ECE/TRANS/WP.29/GRE/2009/4
16 January 2009

REGULATION No. 53

Visibility of adaptive front-lighting systems (AFS) for motorcycles and glare

Proposal for Supplement 11 to the 01 series of amendments to Regulation No. 53

EXPLANATION ABOUT "THE HORIZONTAL INCLINATION", "THE BANK ANGLE"
AND THE ANGLE " δ ".

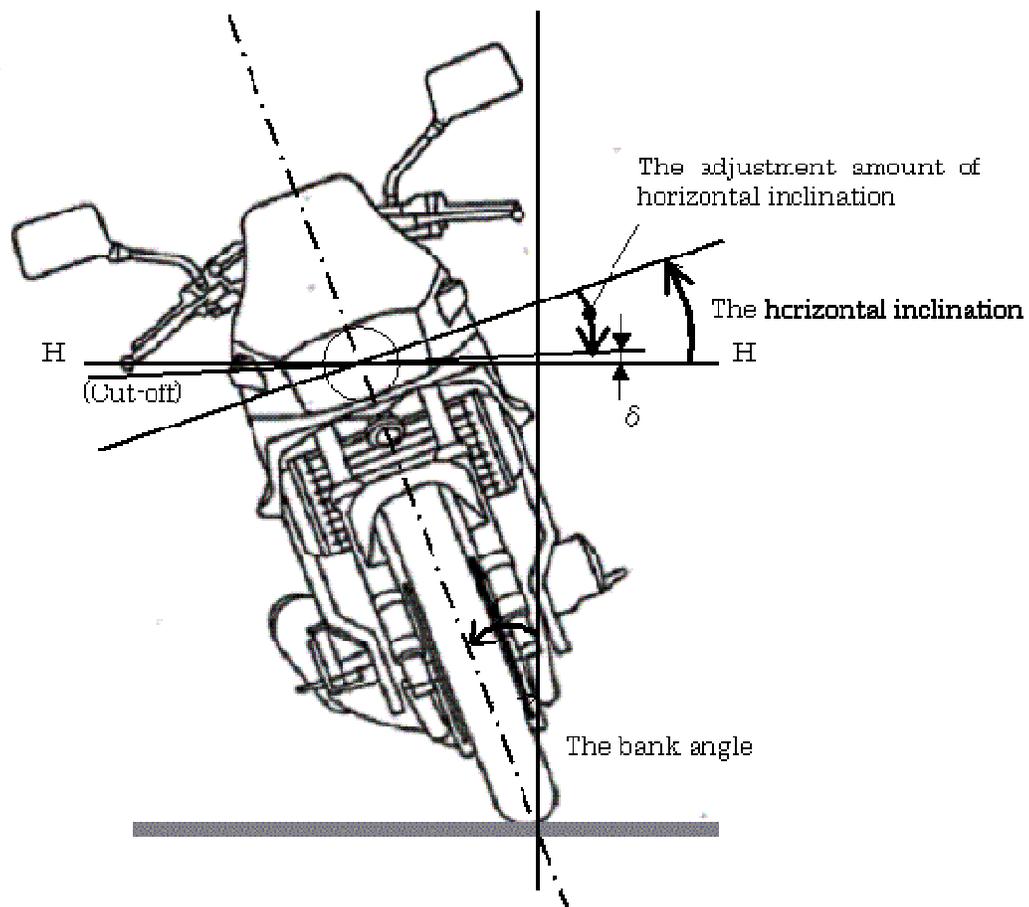
"6.2.5.5. A HIAS may be installed. However, the adjustment amount of horizontal inclination shall not exceed the vehicle's bank angle.

6.2.5.6. The requirement in paragraph 6.2.5.5. shall be tested under the following conditions:

In the absence of specific instructions, test vehicle shall be set as specified in paragraph 5.4. Incline the vehicle with the following conditions and measure the angle δ created by headlamp cut-off line (in case of asymmetrical beam headlamp, its horizontal part of cut-off is used) and HH line. (see drawing in Annex 6).

- (a) Maximum horizontal inclination adjustment angle specified by the manufacturer (to left and to right).**
- (b) Half of maximum horizontal inclination adjustment angle specified by the manufacturer (to left and to right).**

The system shall be considered satisfying the requirements of paragraph 6.2.5.5., if all measured angles δ are not less than zero. This may be demonstrated by the manufacturer by other means accepted by the authority responsible for type approval."

Figure 1. Description of the Function of the Inclination Angle adjustment-Type AFS

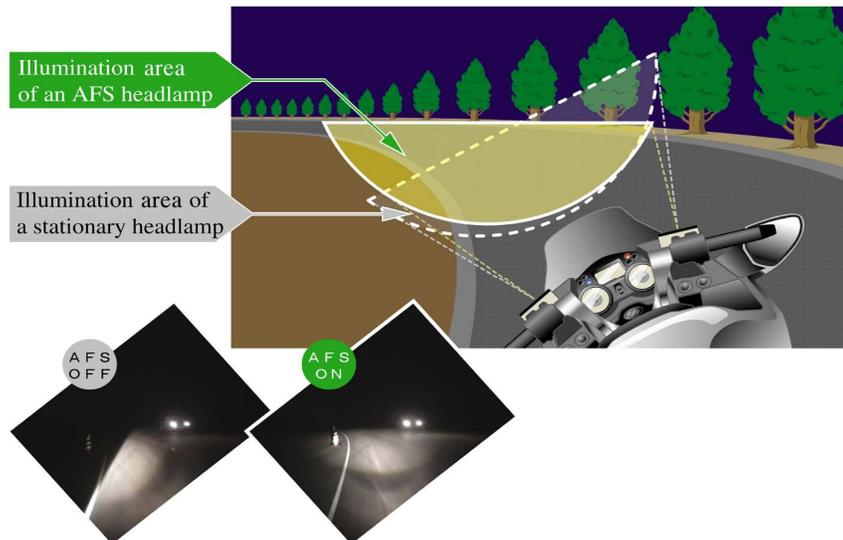
In the case of a motorcycle, due to its driving characteristics, the headlamp inclines with the vehicle when the vehicle is running on a curved road, narrowing the illumination area of the headlamp in the travelling direction. Therefore, by adjusting the variation of the headlamp's light distribution from that when the vehicle is upright (i.e.: in the standard condition), to keep the illumination area wide enough, the visibility is expected to improve.
